ADDENDUM NO. 1

WASHINGTON STATE PARKS AND RECREATION COMMISSION
SUN LAKES STATE PARK
SEWER LIFT STATION REPLACEMENT
EW-C6702

DATE: OCTOBER 10, 2024

LIFT STATION DETAILS 2

CHAIN-LINK FENCE

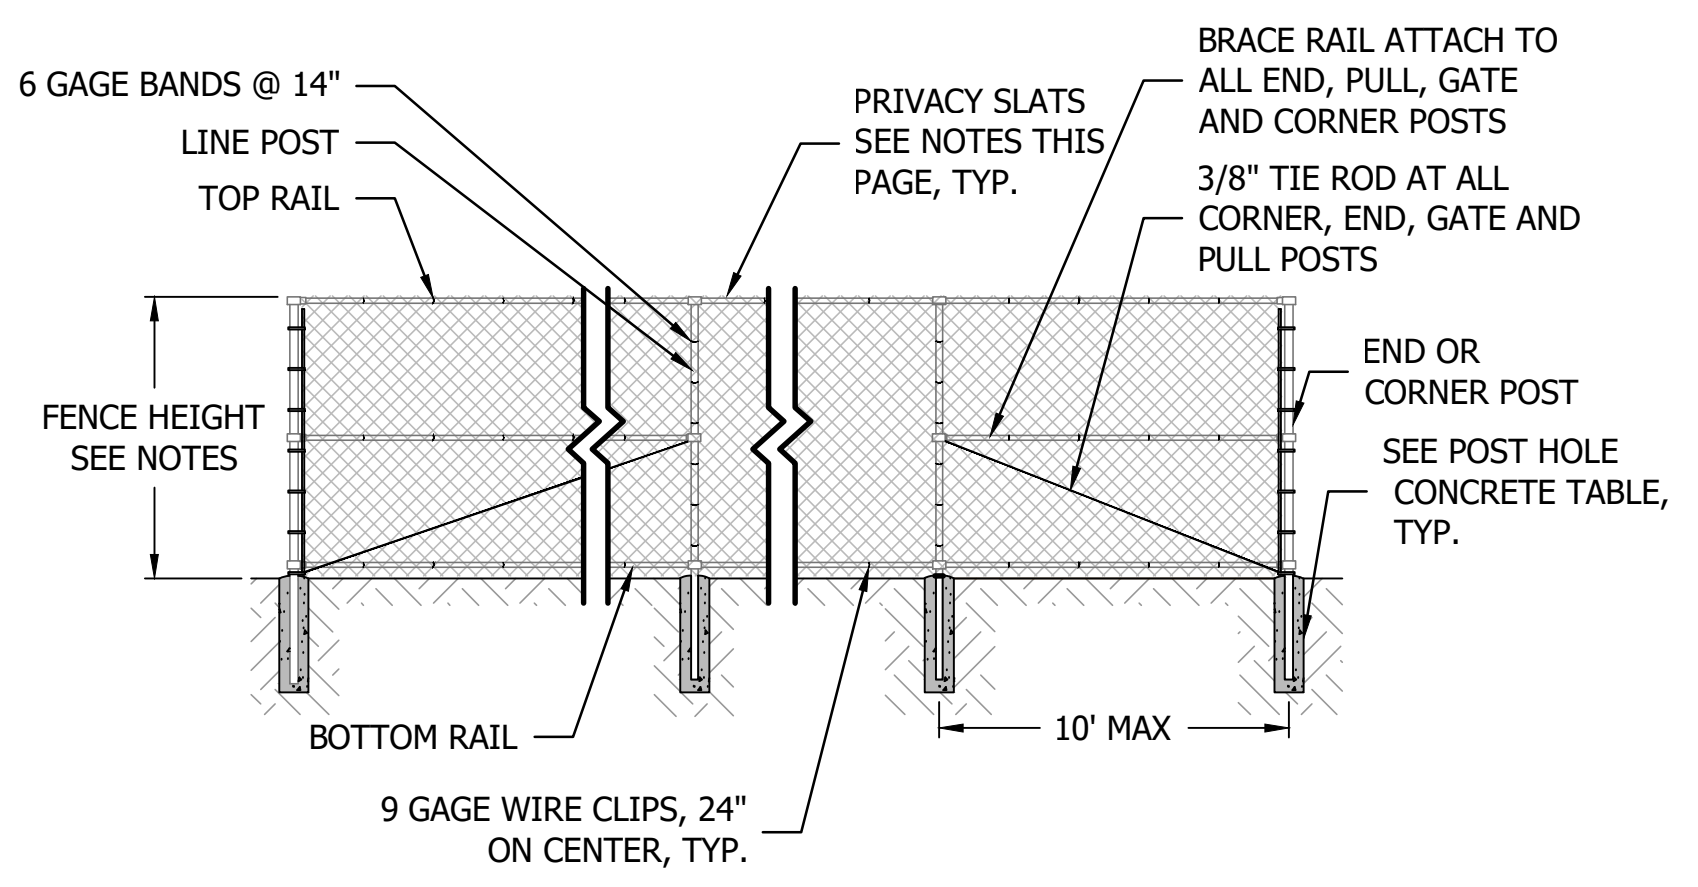
REPLACE plan sheet 12 with the attached page. Note number 5 was added to detail LS09 stating the fence height as 6-feet.

- NOTES:
1. NOTE: MINIMUM DEPTHS BASED ON IBC GRAVEL(GW) OR SANDY GRAVEL(GP) SOIL TYPES PER IBC TABLE 1804.2.
 2. CONCRETE FOR ALL FOOTINGS SHALL BE 4000 PSI CONCRETE.
 3. ALL CHAIN LINK FENCE SHALL BE VINYL COATED.
 4. PROVIDE VERTICAL PRIVACY SLATS WITH VERTICAL LOCKING FEATURE, NEUTRAL COLOR.
 5. FENCE HEIGHT TO BE 6'.
